MFN 06-308, Supplement 19

Response to Portion of NRC Request for

Related to ESBWR Design Certification Application

Classification of Structures, Systems and Components

FMEA Methodology

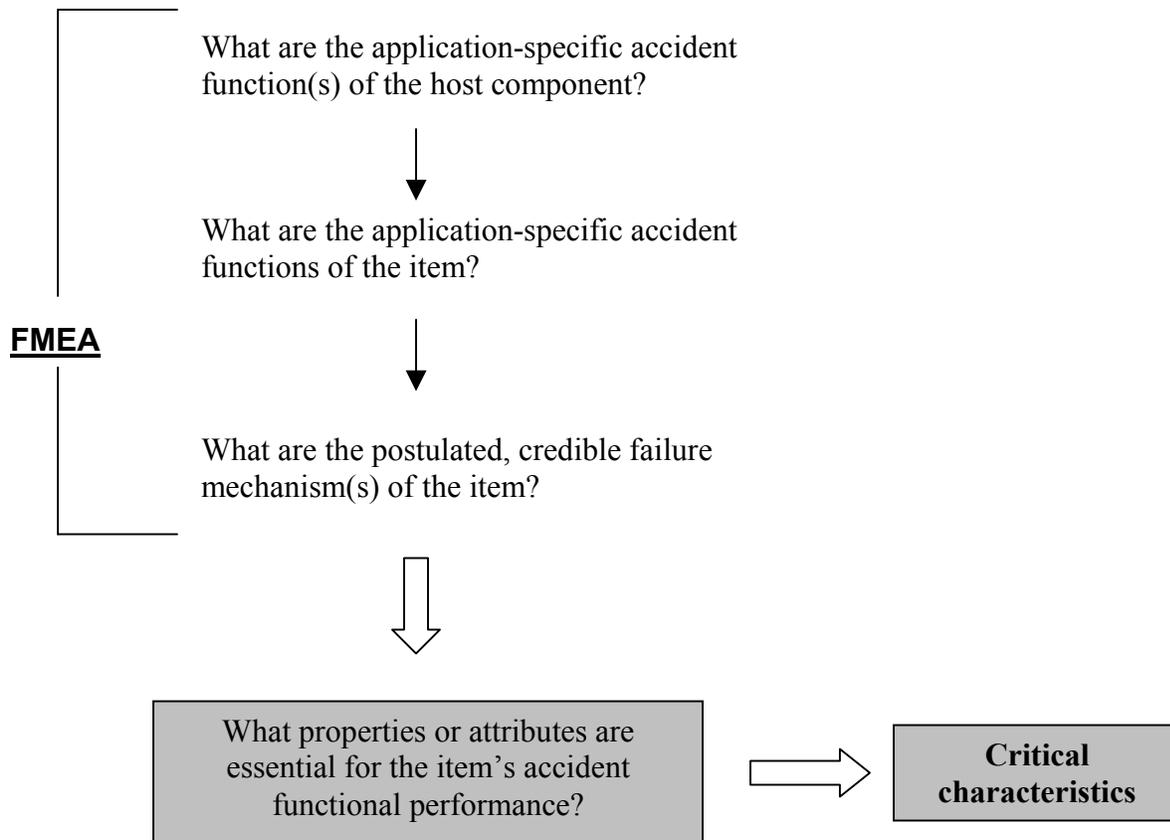
As part of the technical evaluation, the Failure Modes and Effects Analysis (FMEA) documents the credible failure mechanisms that are likely to occur under the RTNSS item's service conditions (i.e., normal and accident) and their impact on the functionality of the item. From the failure mechanisms, the resulting effects on the parent component and system can be determined. The critical characteristics for design can be derived from the RTNSS parent component's required functionality and the critical design requirements necessary to mitigate the credible failure mechanisms determined in the FMEA.
